June 12, 2013

Re: New York Independent System Operator, Inc., *Response to Request for Additional Information Concerning Proposed Tariff Revisions to Establish and Recognize a New Capacity Zone, Request for Shortened Notice Period and Request for Expedited Action*, Docket No. ER13-1380-000

Graph 1

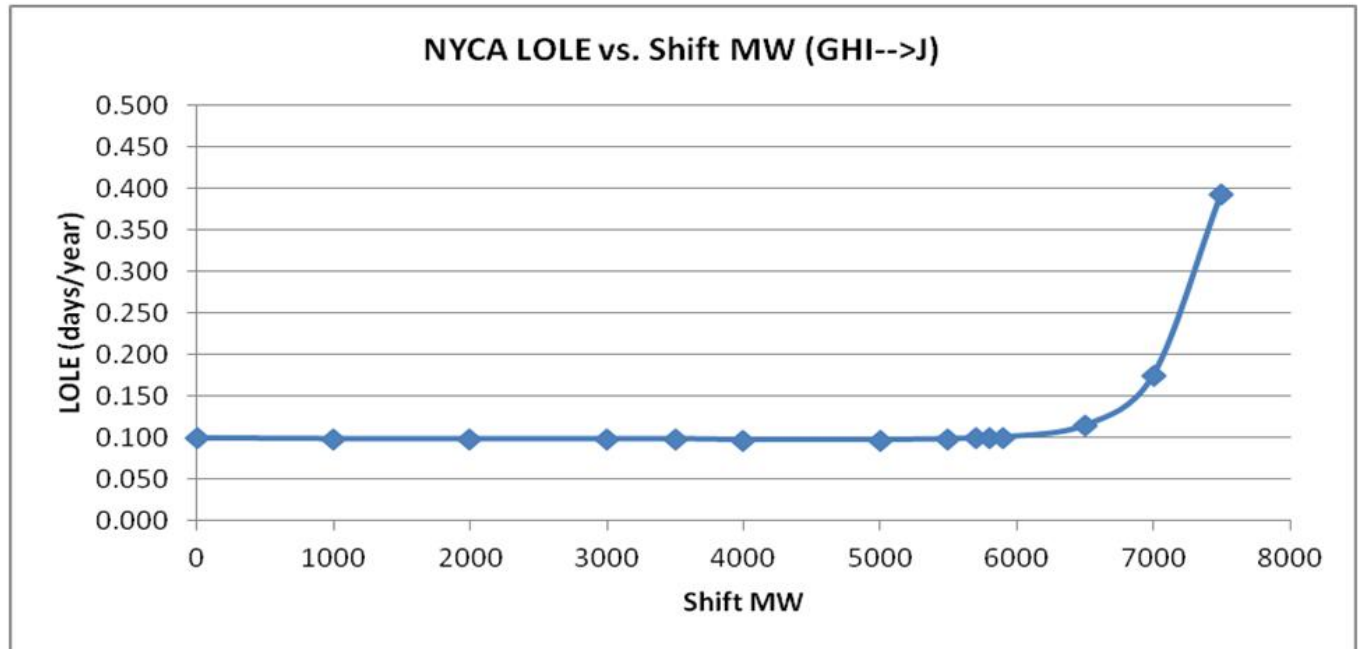
"What quantity of fungible transfer capacity (MW) would have been sufficient for Load Zone K to be included in the proposed new capacity zone? Please explain the basis for your answer?"

Based on analyses using the MARS model, which are described in the Chao/Adams Affidavit,⁴² the NYISO demonstrated that all of the existing capacity in Load Zones GHI could be replaced by capacity in Load Zone J. Thus, it is fully fungible; *i.e.*, it can be substituted one-for-one.

The following graphic (Graph 1) illustrates the impact of shifting up to 6,000 MW of capacity. These results were presented to NYISO Stakeholders at the March 28, 2013 and April 18 Installed Capacity Working Group meetings.⁴³
